UNITED STATES
NUCLEAR REGULATORY COMMISSION
OFFICE OF INSPECTION AND ENFORCEMENT
WASHINGTON, D.C. 20555

IE Circular No. 79-24

PROPER INSTALLATION AND CALIBRATION OF CORE SPRAY PIPE BREAK DETECTION EQUIPMENT
ON BWRs

Figure 1 Core Spray System Pipe Break Detection Instrumentation

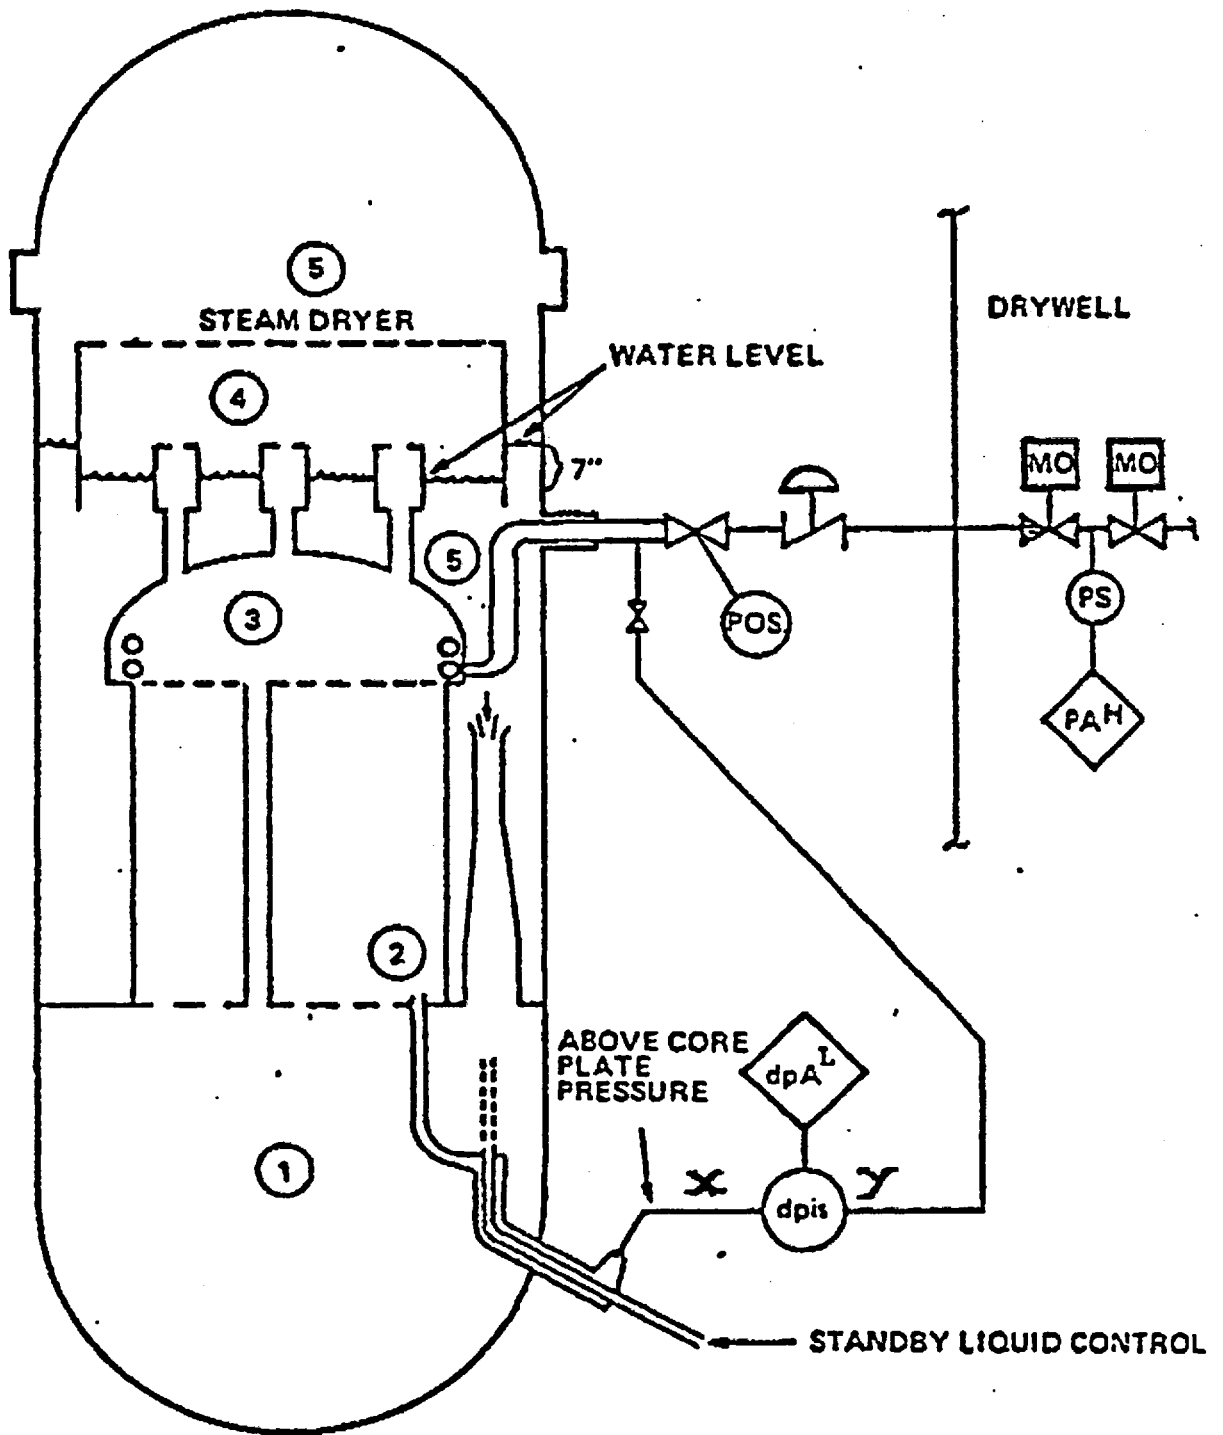
The licensee's investigation of the downscale deflection revealed that the original piping arrangement and calibration did not adequately take into account the effect of density changes of the water in the pressure leg connections. The original installation had the high pressure side of the dp instrument (see attached Figure 1) connected to the reference leg in the vessel (Figure 1 Connection X) and the low pressure side to the core spray piping outside the vessel but inside the drywell (Figure 1 Connection Y). With the piping intact, this arrangement senses the pressure difference between bottom and top of core. With a break in CS piping in the annulus area the instrument then senses the additional pressure drop across the separators ($dp \approx 7$ psi additional) and dryers ($dp \approx 7$ -inches water). This installation was in accordance with GE design requirements.

Also in accordance with GE instructions the calibration of the dp instrument was performed with the reactor in the cold condition and the alarm was set to trip at 5 psid increasing. Because of this cold calibration the dp instrument then indicated full downscale negative during operation. This negative dp was due to the heat up of the reference leg (Figure 1 Connection X) which caused the fluid density to decrease as the plant reached hot conditions. The magnitude of this dp was determined to be about 3.5 psid following completion of the modification discussed below.

Adding the 3.5 psi downscale deflection to the 5 psi alarm setpoint results in a total required deflection of 8.5 psi to initiate the alarm at the setpoint. Since the total dp available across the separators and dryer is only 7 psi (1.5 psi less than the total required deflection), the alarm would not be actuated by a CS pipe break in the annulus. Therefore, the original installation, including calibration procedure, was deficient.

Further review by the NRC has revealed that the above described lack of trip which precipitated the piping modification and technical specification change at DAEC, exists on other operating BWRs and that BWRs under construction have or will have piping arrangements on the core spray system (i.e., high pressure core spray system on BWR 5's and 6's) that will potentially generate the same problem.

The specific concern is that failure of the injection piping would not be detected on the plants in question, because the alarm is the only control room indication involved. The actual differential pressure can only be read at local gauges located on instrument racks in the reactor building.

To correct the problem, Iowa Electric modified the installation by interchanging the pressure leg connections and resetting the alarm to trip at 2 psid decreasing. In this orientation it was found that going from cold to hot produced a 3.5 psid positive deflection. The technical specifications were changed to reflect the revised alarm setpoint.

- "1. BWR operators, who have differential pressure (ΔP) instrumentation which reads only positive values, interchange their core spray line break instrument connections so that the high side connection is to the core spray sparger sensing line and the low side connection is to the above the core plate sensing line. This instrumentation should be calibrated for a zero ΔP reading during cold shutdown; it will then give a positive ΔP reading during normal rated power operation and a pegged zero reading for a line break indication during normal rated power operation.

Also, when this change is made, the recommended alarm setpoint (on decreasing ΔP) setting is 0.5 / 0.25 PSID; and for those plants that have a value in their technical specifications, >0 PSID is recommended as a limit.

- "2. BWR operators, who have installed or who prefer to install ΔP instrumentation (e.g., -10 to +10 PSID) that covers their range of negative and positive ΔP values and who continue with the instrument high side connected to the above the core plate sensing line, use the same alarm set point of 0.5 / 0.25 PSID (and a technical specification limit, if applicable, of ≤ 1 PSID). The instrument should again be calibrated to read zero ΔP during cold shutdown."

1. If your facility utilizes a core spray leak detection system similar to that described above, determine if the described problems exist. If so, initiate appropriate corrective action at the next planned refueling outage.
2. Propose changes, as appropriate, to those technical specifications which must be revised as a result of your modifying the item above.
3. For interim operations until full corrective measures have been taken it is recommended that direct readings from do gauges be periodically taken or setpoints changed along with providing necessary instructions to the operators regarding indications from this system.
